**CASE NUMBER:** C15-2020-0029

**ADDRESS:** 1711 WATERSTON AVE

**1711 Waterston Avenue Addition BOA Postposted Case Summary and Revision**

Date: August 10, 2020  
Owners: Molly Rosenblatt and John Peet  
Case #: C15-2020-0029

# 1 Proposed Site Plan

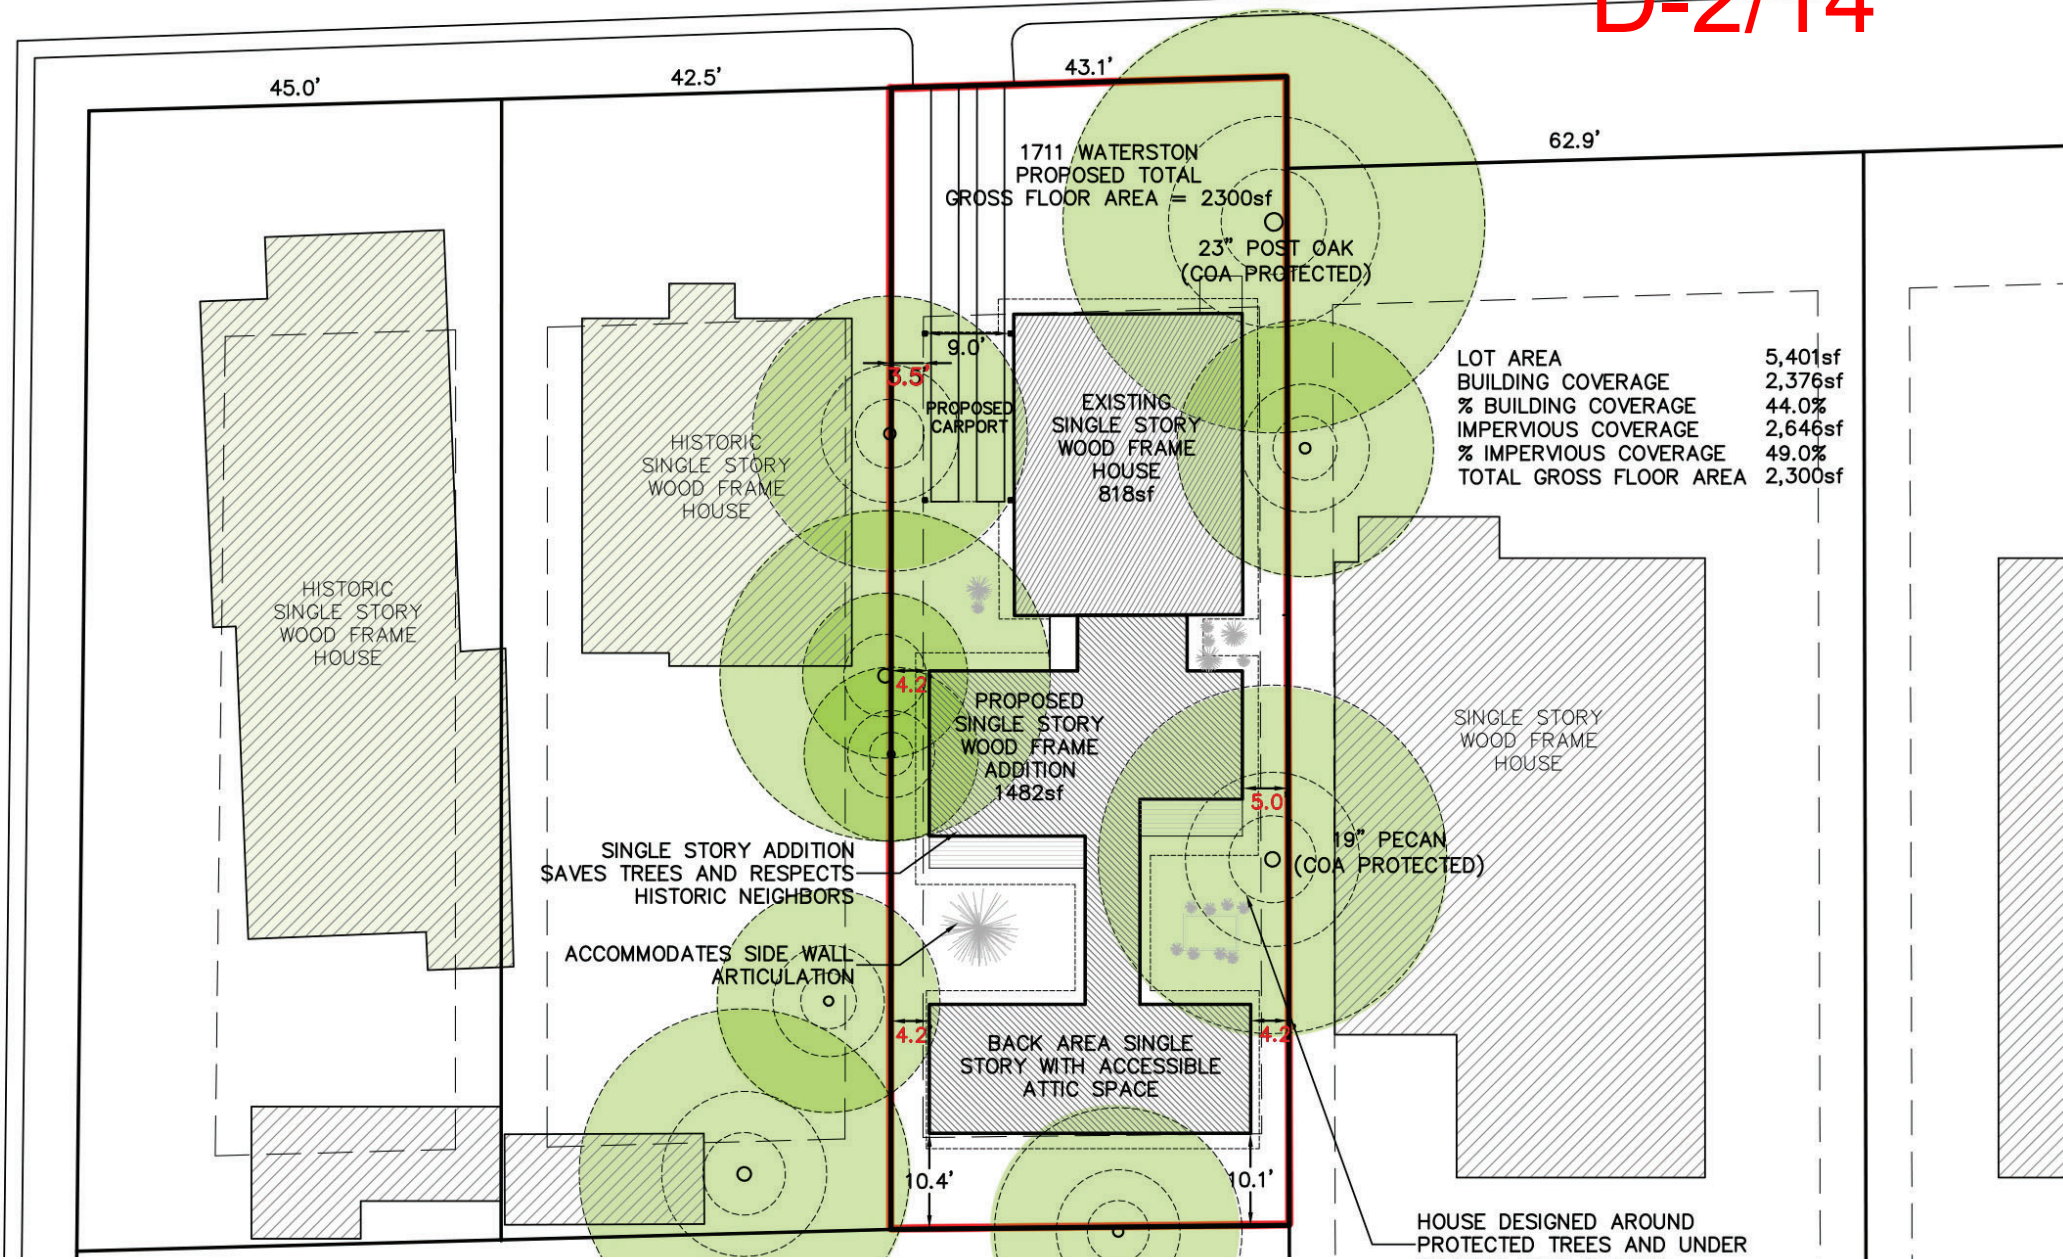
Variance request reduced: We have included an accessible attic at the back portion of the house and moved it out of the back setback. We have requested a reduced building coverage of 44% and impervious coverage of 49%. We are only asking for adjustments to the side setback as shown and as follows:

To accomodate 9' wide carport requires 3.5' side setback

Allow 4.2' side setback at west and 4.2' side setback at east (back portion only). All setbacks requests already otherwise allowed in 25-2-779

**3 Proposed Side Elevation Viewed from driveway**

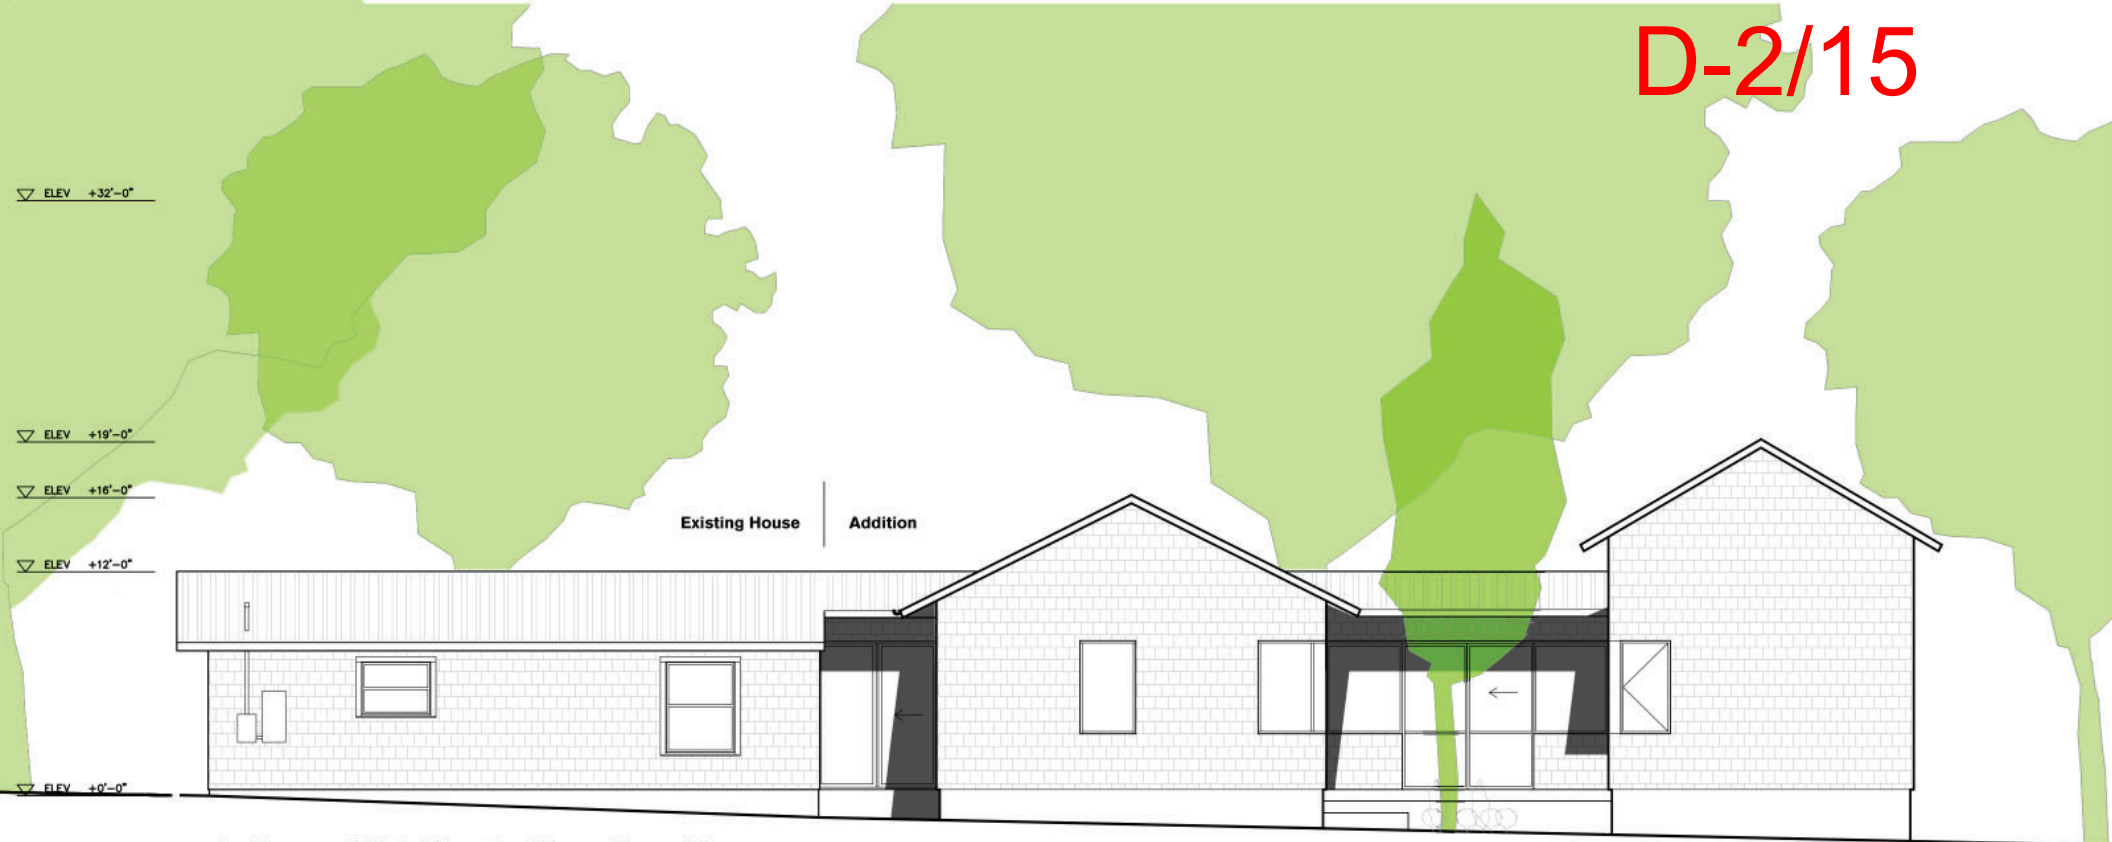
We have greatly reduced our variance requests by designing a habitable attic at the back portion of the addition where there is more available height under the tree canopy. We have encroached on the pecan tree's critical root zone from the north and south (adding more living space at the north and moving the back portion out of the previously requested setback) but is allowable according to Tree Review. There are two protected critical root zones which the design is trying to avoid, and has done so as suggested in consultation with COA Tree review.
